FSCF Changes into Final Design

Slides from Arup Final Design Kick-Off Meeting (11/7/17)

April 11, 2018

EXC Scope Changes – Underground Structural

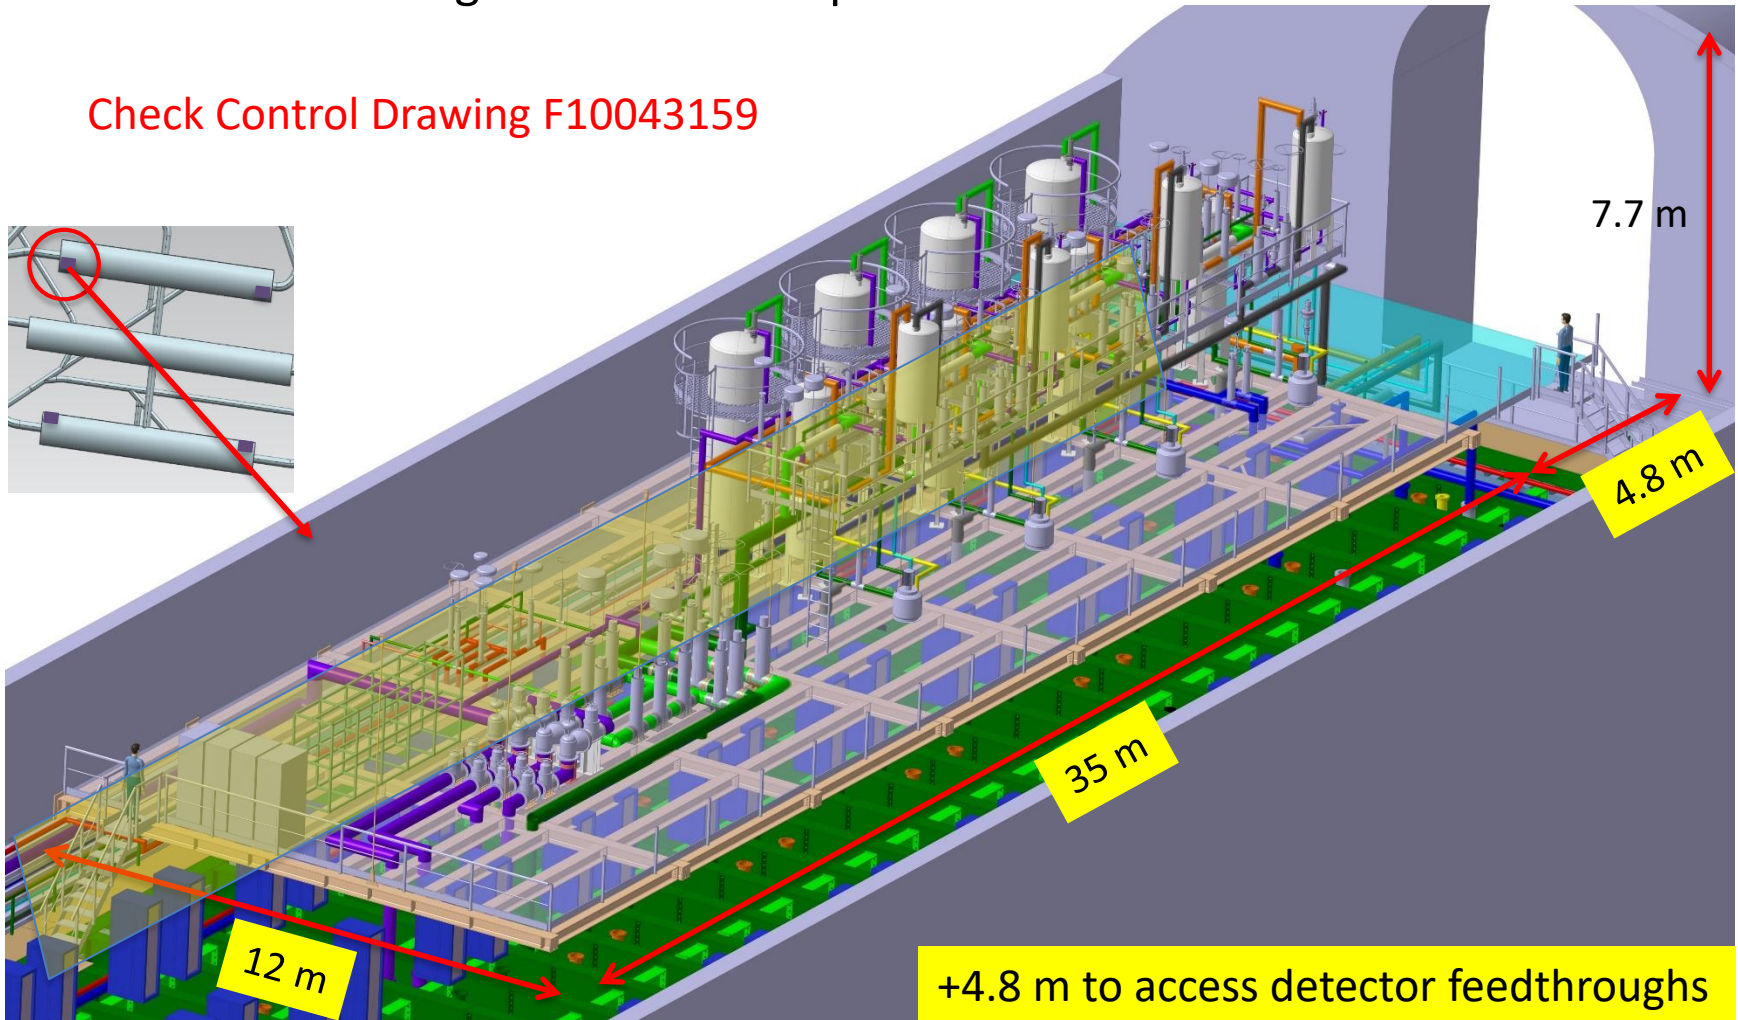
Add anchors on ceiling and wall for suspension of mezzanine

- The Final EXC Design shall include addition of connections/supports and wall mounted supports design for 10m x 35m mezzanines on the CUC side of each detector chamber.
- The Final EXC Design shall include a pattern of ten – 100 metric ton capacity lifting eyes above each mezzanine, and two – 100 metric ton capacity lifting eyes above each cryostat bridge, for material lifting at each location.
- Each anchorage (lifting eye) to be designed and installed to provide 100 metric ton capacity.

BSI Scope Changes – Underground Structural

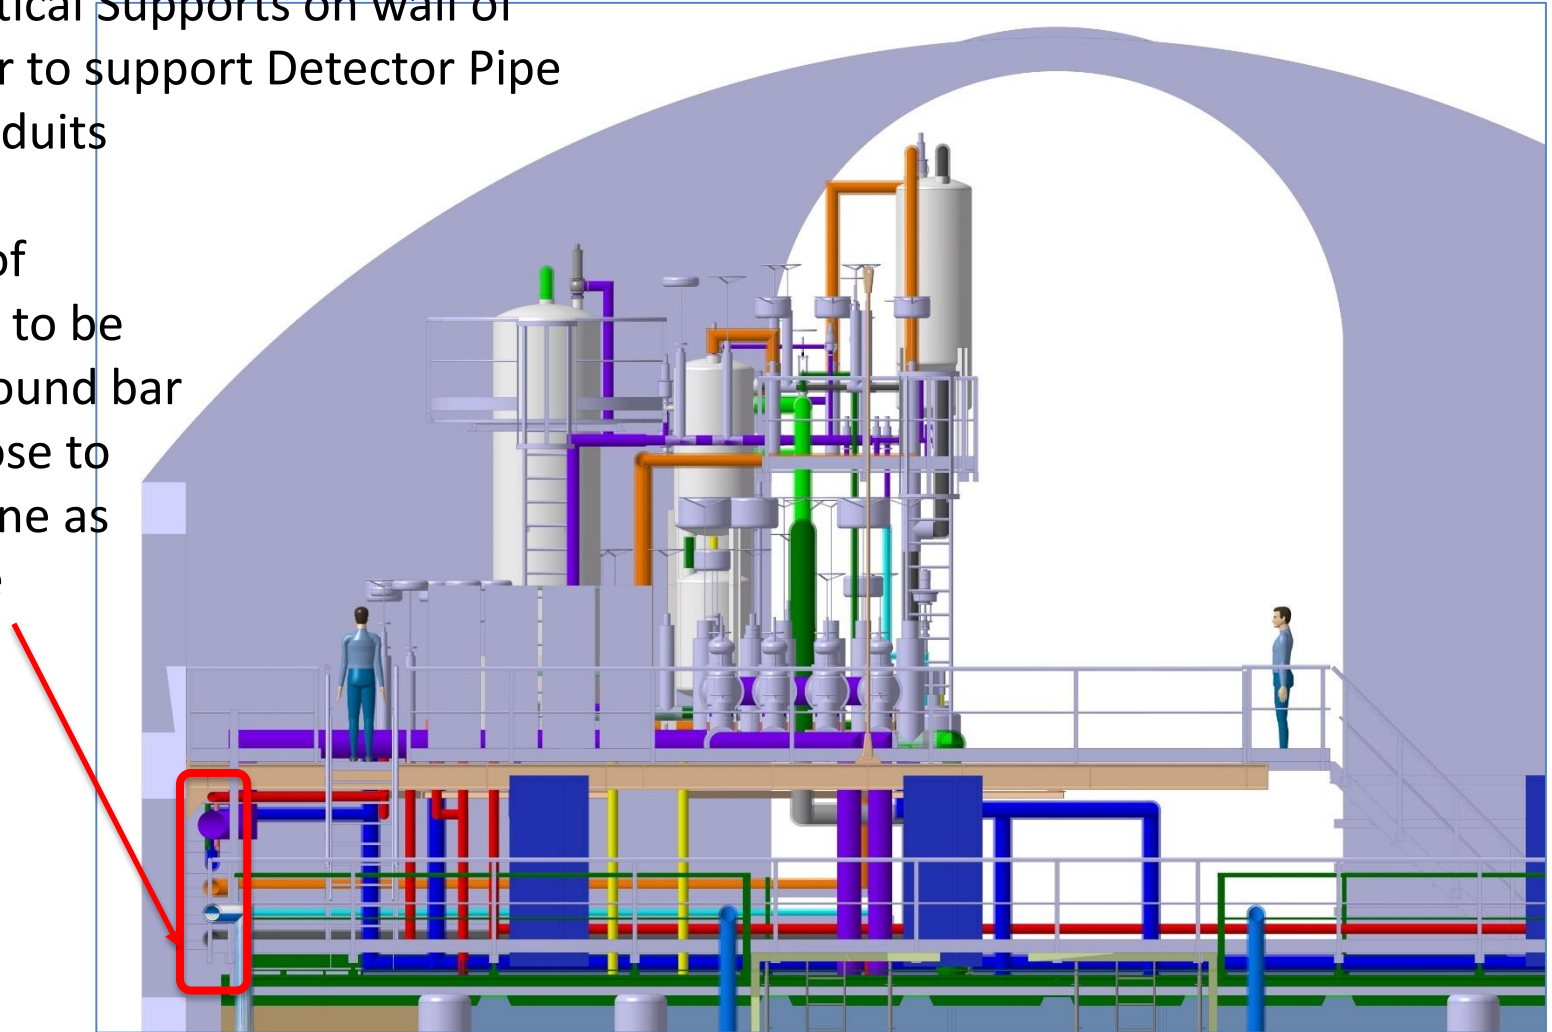
- Add Vertical Supports on wall of chamber to support Detector Pipe and Conduits
- Height of Support to be from ground bar to as close to spring line as possible

Underground Mechanical – Cryostat Ventilation

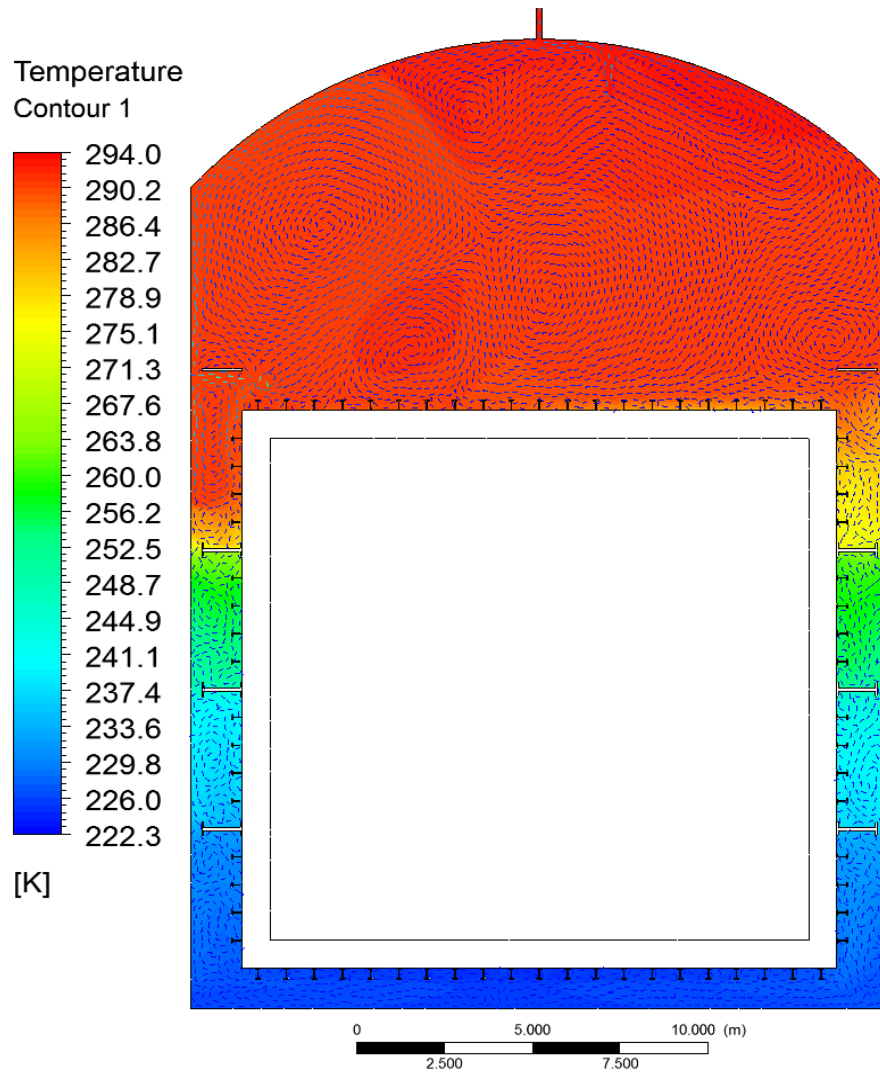
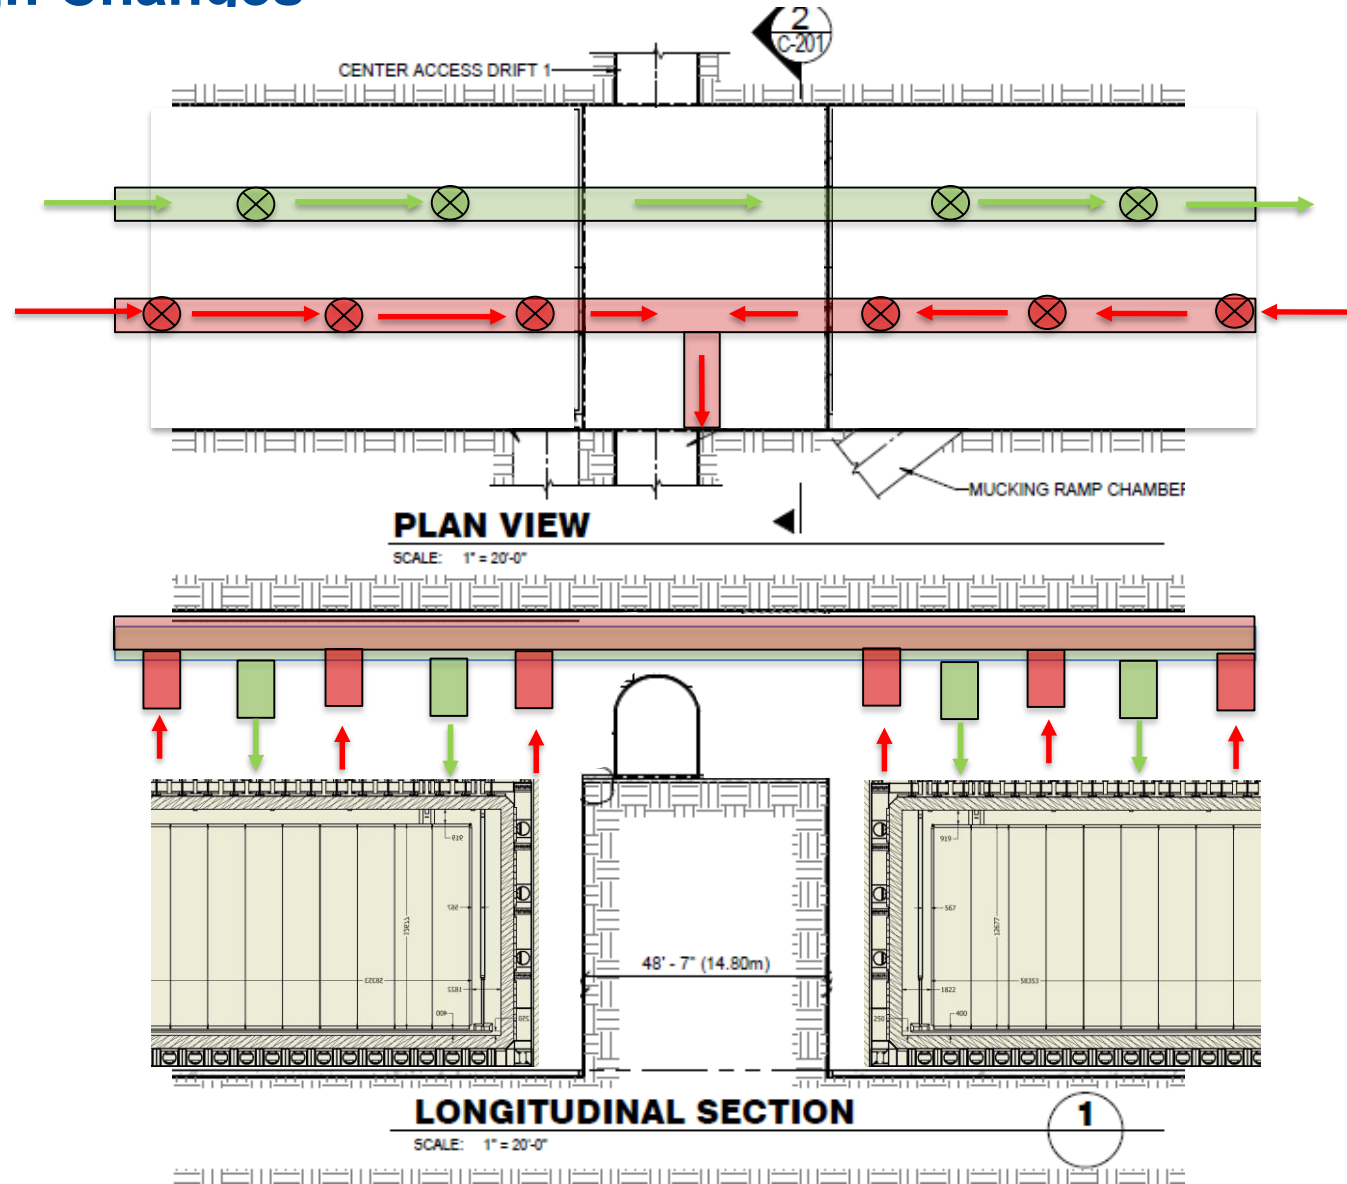
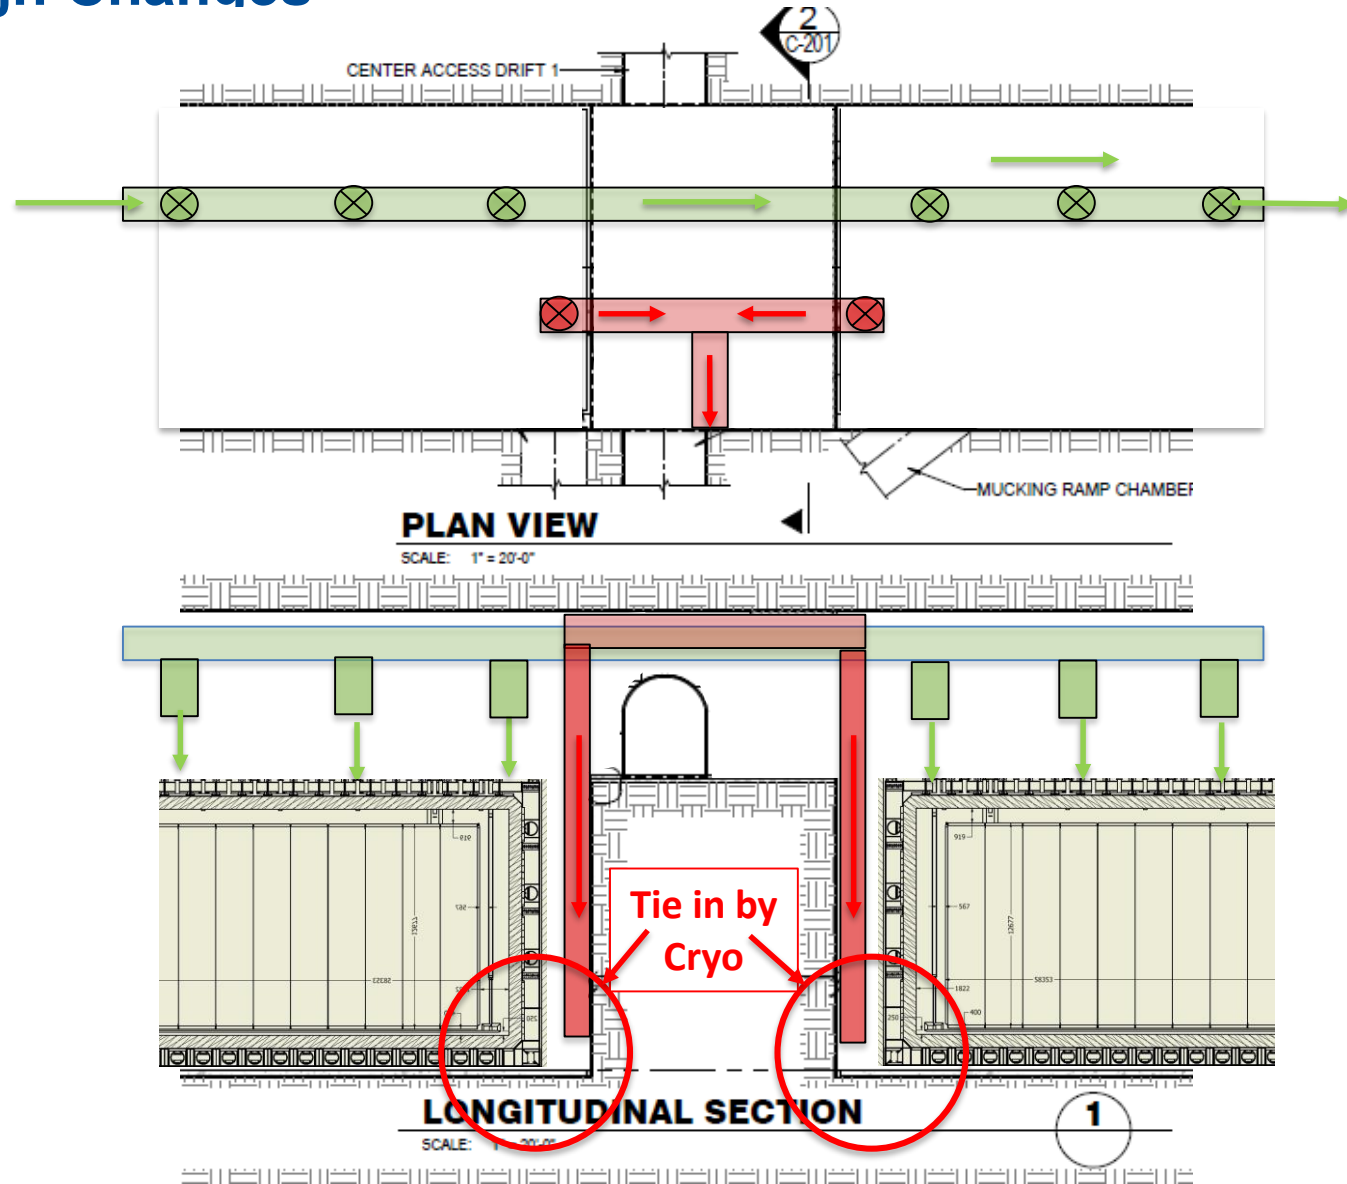
- A condensation analysis has been performed which has determined that the current Preliminary design for Cryostat ventilation does not provide for adequate circulation to prevent condensation from occurring

- Required Final Design Arrangement
- Required for all 4 Cryostat Chambers

Underground Communications

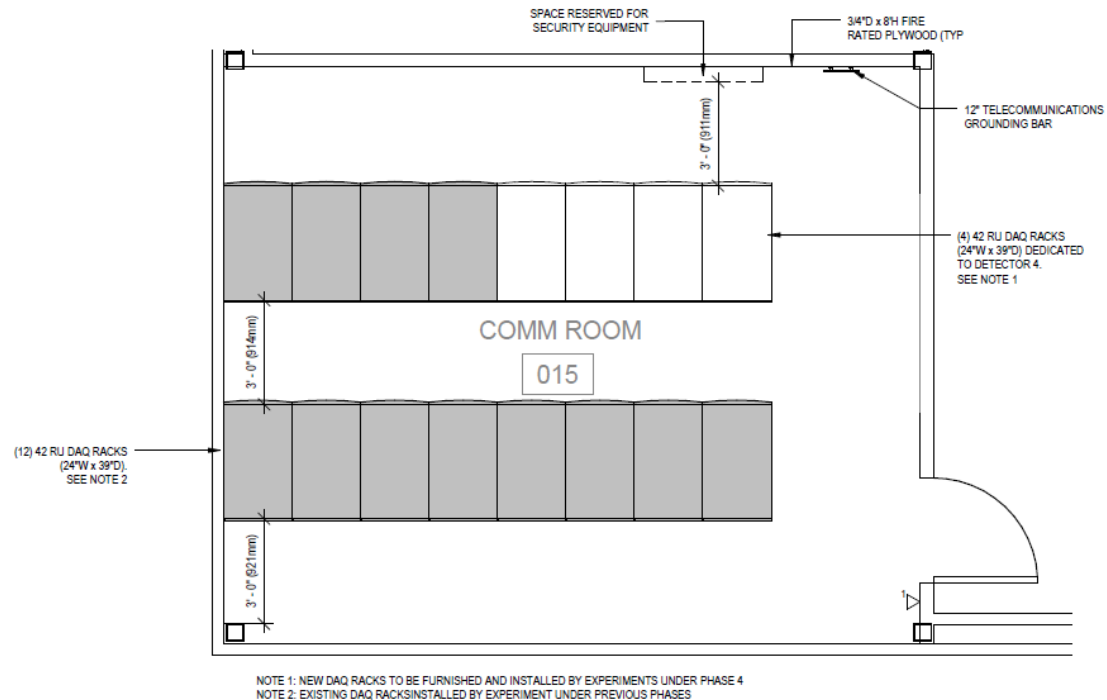
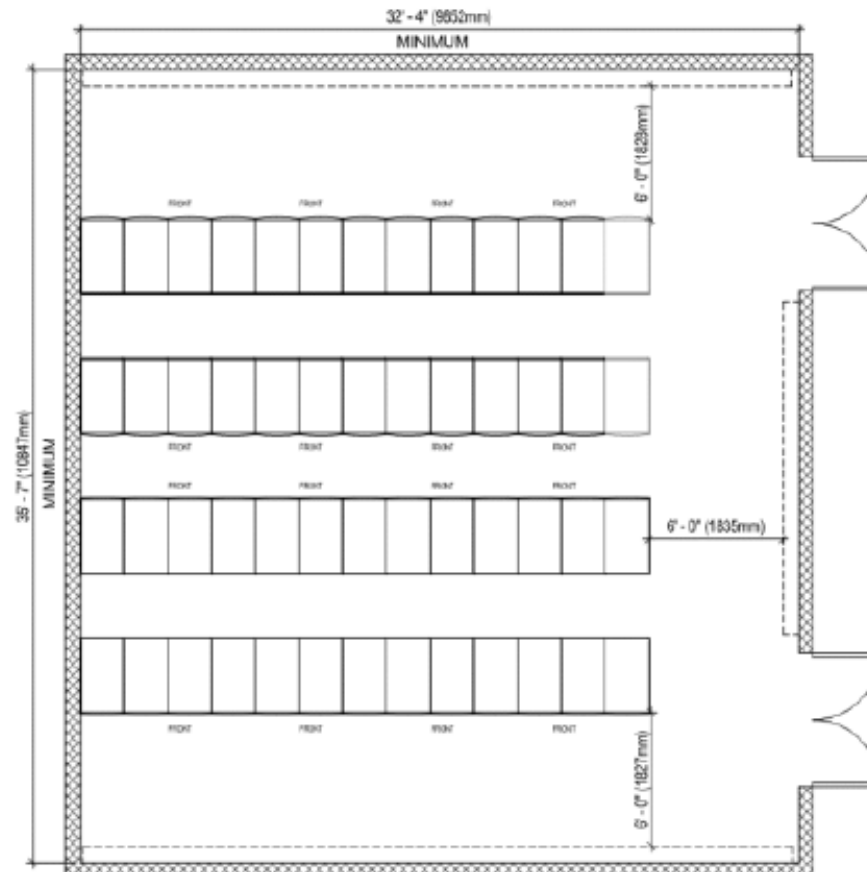
- The Preliminary Design calls for a total of 16 racks in the CUC Communication room

- The Final Design requires a total of 52 racks in the CUC Communication room

Changes to EXC scope – Infrastructure – 5000L Decline Drift

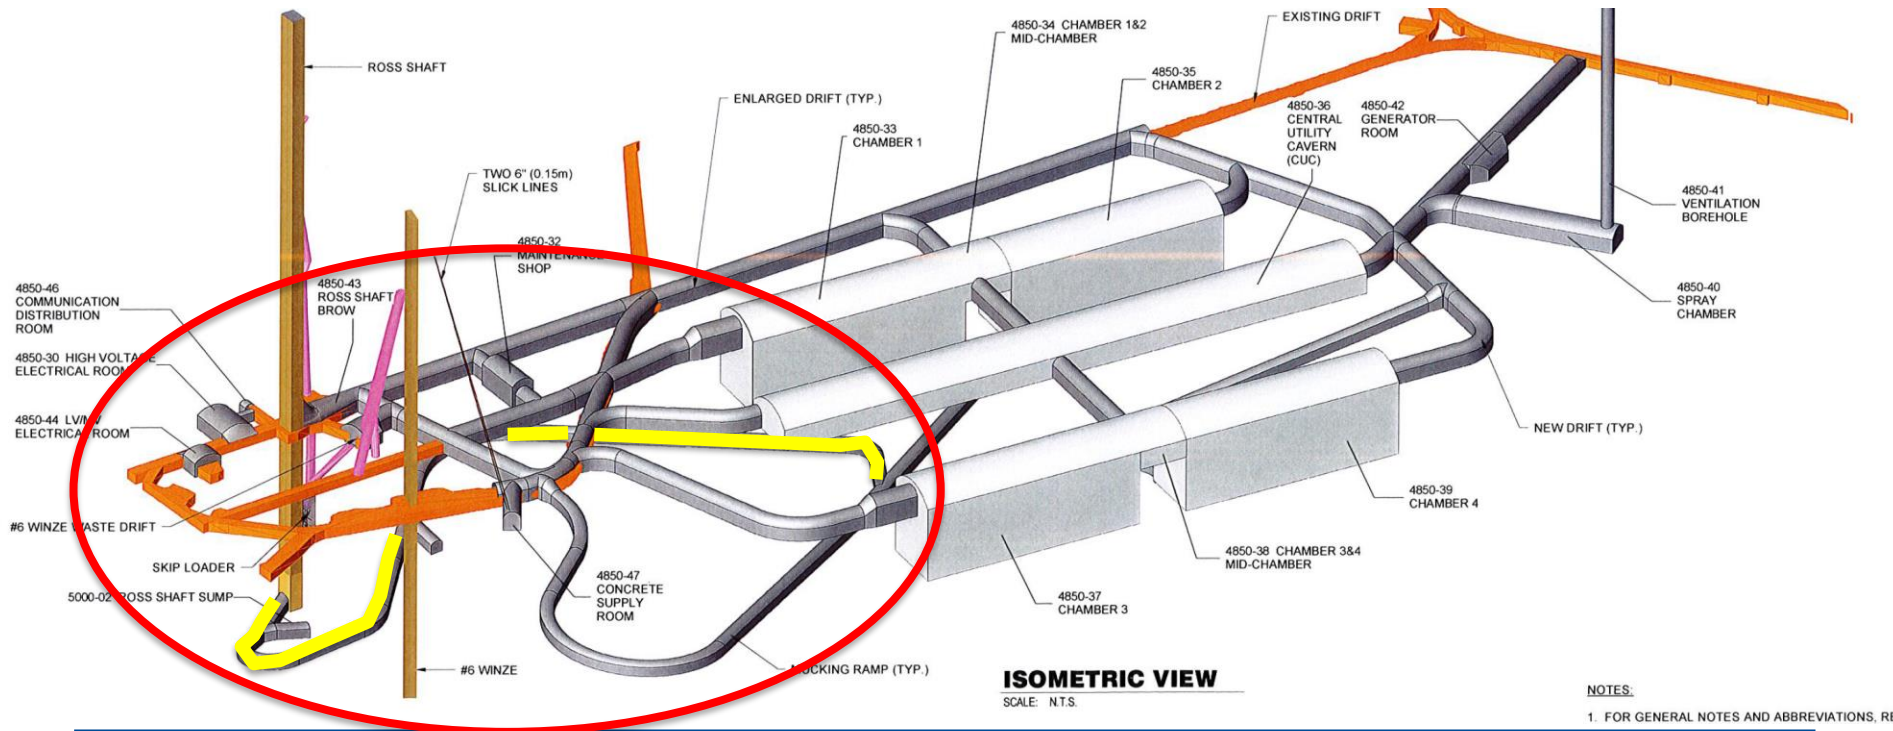
- The installed Ross Shaft collection system will eliminate the 5000L decline drift previously included in the PDR and may influence ventilation design.
- The Final EXC Design shall remove the 5000L decline drift from the scope of work.
- The Final EXC Design shall include a water management system to replace the collection system included into the 5000L ramp.
